Access Compliance Report

Public Rights-of-Way

(Curb Ramps)

Intersection ID: 10033765	Main Street: OXFORD COMMONS DR	Cross Street: N/A	Location: S
ADA ID: 80417D25C3AB	Ramp Type: Perp	Initial Pass/Fail: Fail	Overall Compliance: No
Severity Score: 13.75			
Codes/Mitigation Info/Possible Solution		Field Measurements/Component Compliance

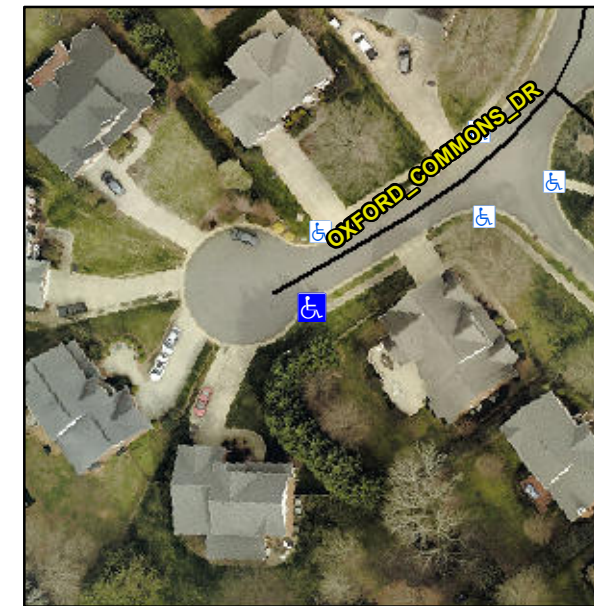
Not Found, R304.2.2

Compliance	Description	Data	Compliance	Description	Data
N/A	Ramp Length (in)	46.0	No	Ramp Slope (%)	9.3
Yes	Ramp Width (in)	48.0	Yes	Ramp XSlope (%)	3.7
N/A	Flare Type LT	N/A	N/A	Flare Type RT	N/A
N/A	Flare Slope LT (%)	N/A	N/A	Flare Slope RT (%)	N/A
N/A	Flare Traversable LT?	N/A	N/A	Flare Traversable RT?	N/A
N/A	Landing Length (in)	N/A	N/A	DWS Provided?	N/A
N/A	Landing Width (in)	N/A	N/A	DWS Contrast?	N/A
N/A	Landing Slope (%)	N/A	N/A	DWS Length (in)	N/A
N/A	Landing X Slope (%)	N/A	N/A	DWS Full Width?	N/A
N/A	Landing Curb? (Y/N)	N/A	N/A	DWS Offset (in)	N/A
N/A	Shared Landing?	N/A			
N/A	Gutter Ponding?	N/A	N/A	Gutter Slope (%)	N/A
N/A	Gutter Lip Ht (in)	N/A	N/A	Gutter X Slope (%)	N/A
N/A	Painted X Walk1?	No	N/A	Painted X Walk2?	N/A
	X Walk 1 Direction	To NE		X Walk 2 Direction	N/A
N/A	X Walk 1 Width (in)	N/A	N/A	X Walk 2 Width (in)	N/A
	X Walk 1 Slope (%)	1.1		X Walk 2 Slope (%)	N/A
	X Walk 1 X Slope (%)	6.5		X Walk 2 X Slope (%)	N/A

Remove & Replace Entire Ramp.
